Technical Bulletin

PDI-Z13TV Series Arm Mounted TV Audio Chip Failure & Remedy

PDI-Z13TV Series Arm Mounted Television Audio Amp Fix

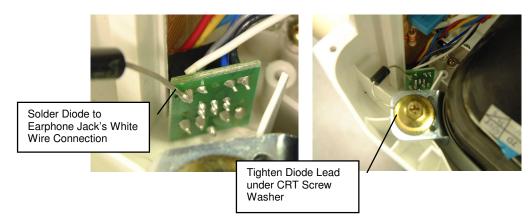
The 8-pin audio chip, type AN7511, is located on the chassis of the 13" model arm set. This problem appears only when a patient uses an external earphone and wraps the earphone cord across the face of the TV after use. Note: the earphone cord must be in actual contact with the face of the CRT and plugged into the TV's jack. If the TV is allowed to rest for an extended period of time, usually after a minimum of 24 hours, and then turned ON with the earphone wire still draped over the face of the CRT, a transient may be induced into the earphone wire. Under the right set of circumstances, the draped earphone wire conducts the transient inside the TV possibly damaging the audio amp IC.

- 1. Remove the television's back cover.
- Located the front mounted earphone jack and solder one lead of a PD148-150 clamp diode (1.5KE51CA) to the ground foil (White Wire Connection) of the earphone jack as shown. Diode polarity is not important.
- 3. Loosen the CRT mounting screw, secure the loose end of the diode under the screw's washer, and tighten.
- 4. Re-install the television's back cover.
- 5. Test the TV for both internal speaker audio and earphone audio.
- 6. Test leakage currents before returning the unit to service.
